Sheet: /
File: HighImpedanceBuffer.sch

Title: High Impedance Buffer

Size: USLetter	Date: 2019-10-01	**Rev: 4**
KiCad E.D.A. kicad (5.1.2)-1		Id: 1/1

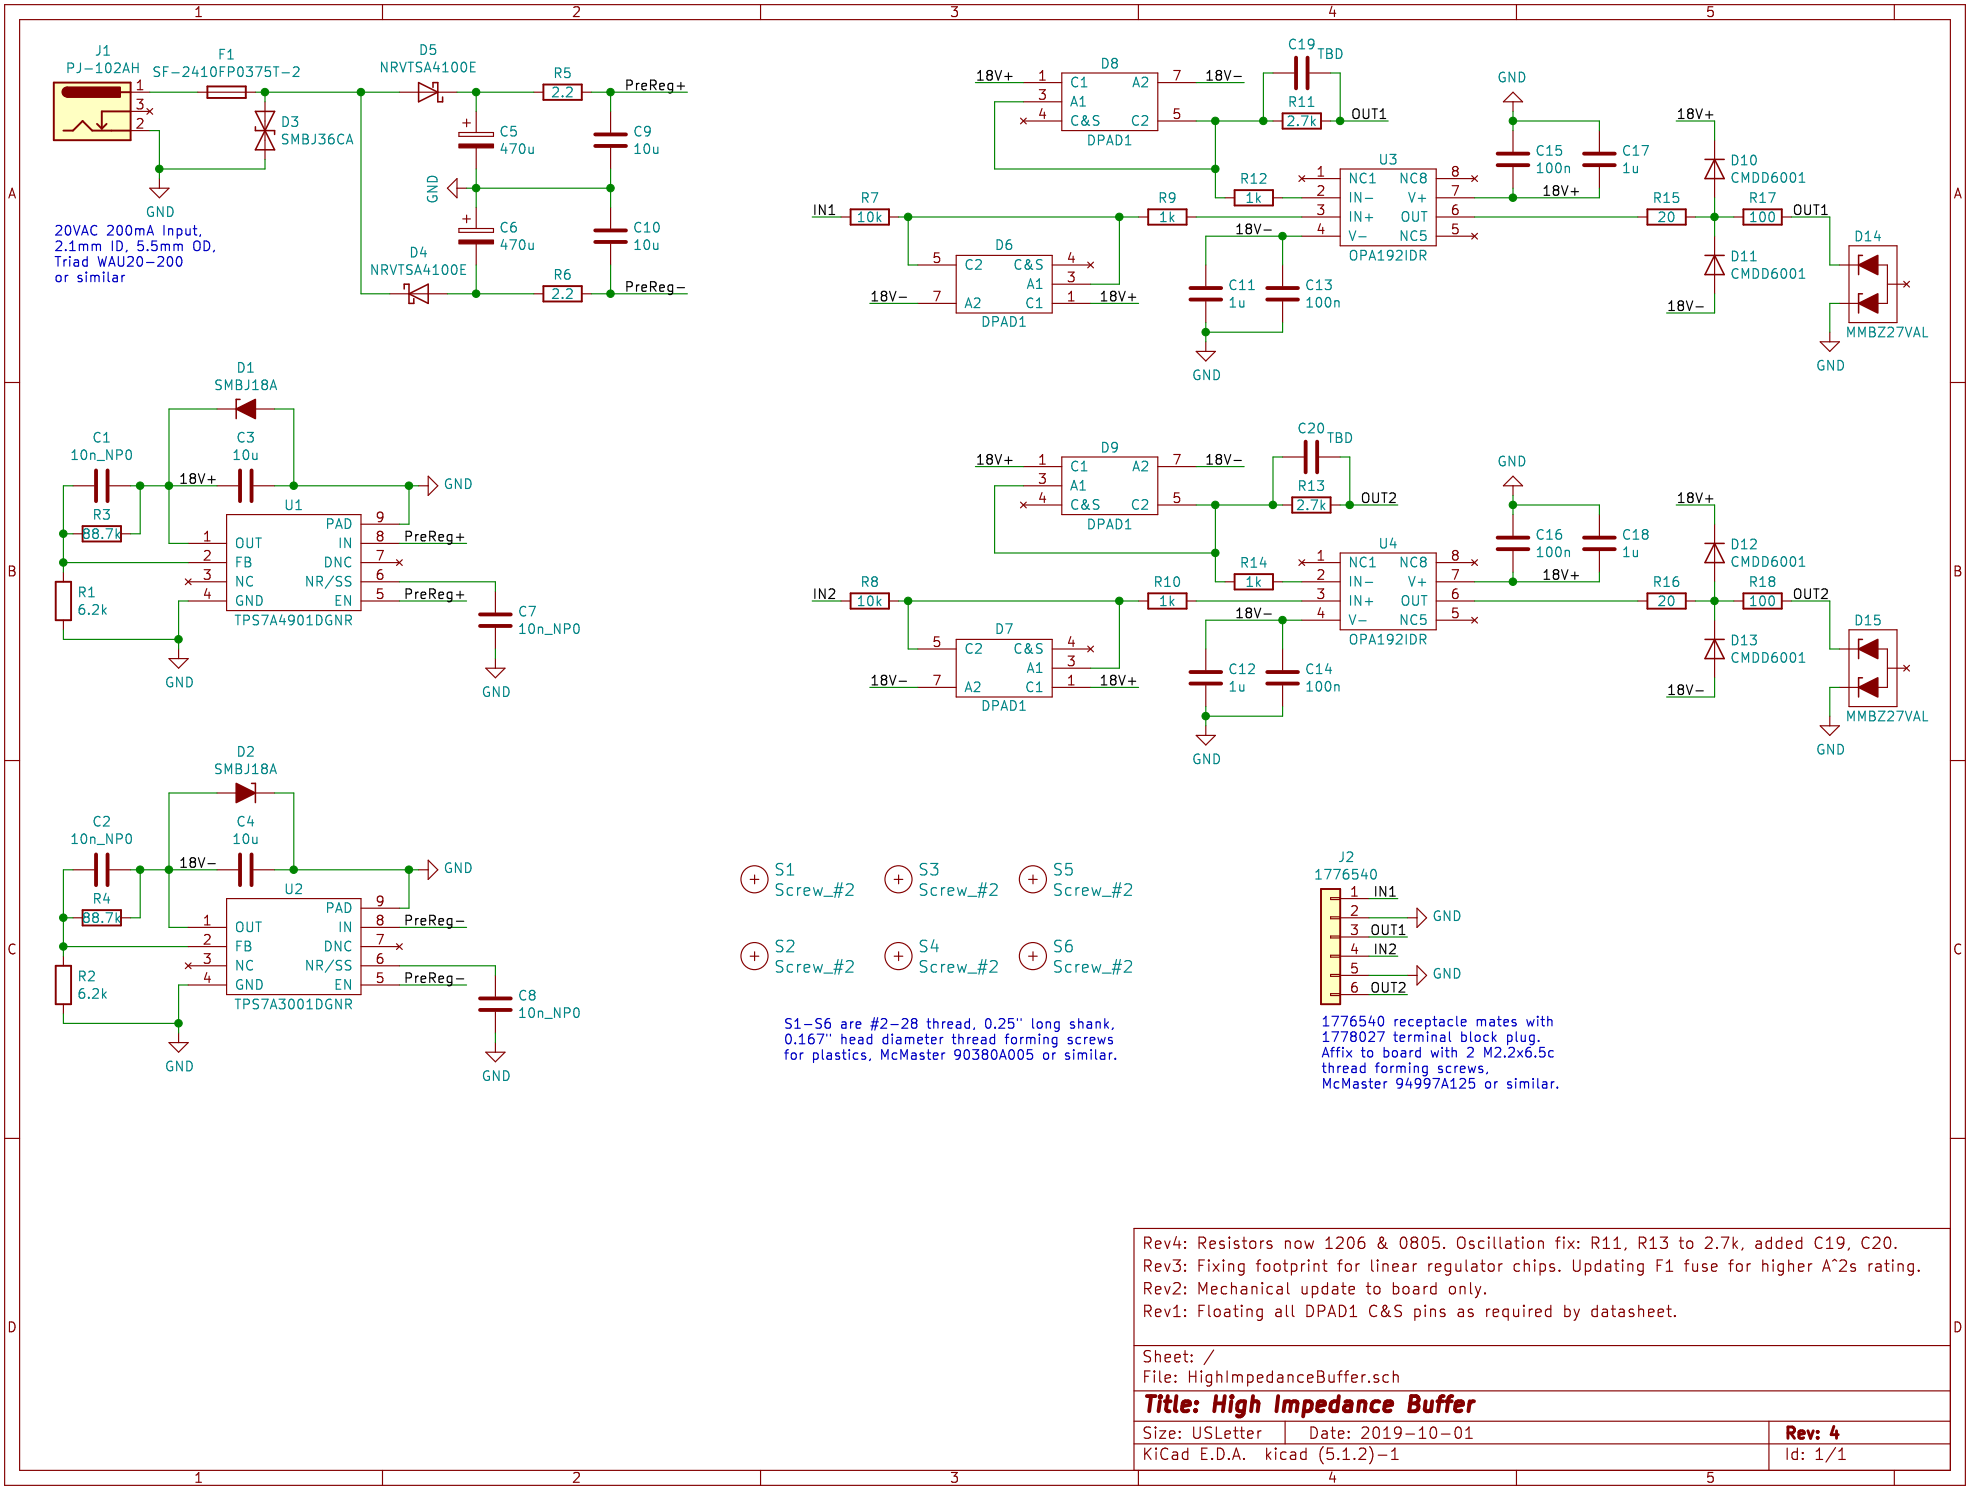
Rev4: Resistors now 1206 & 0805. Oscillation fix: R11, R13 to 2.7k, added C19, C20.
Rev3: Fixing footprint for linear regulator chips. Updating F1 fuse for higher A^2s rating.
Rev2: Mechanical update to board only.
Rev1: Floating all DPAD1 C&S pins as required by datasheet.
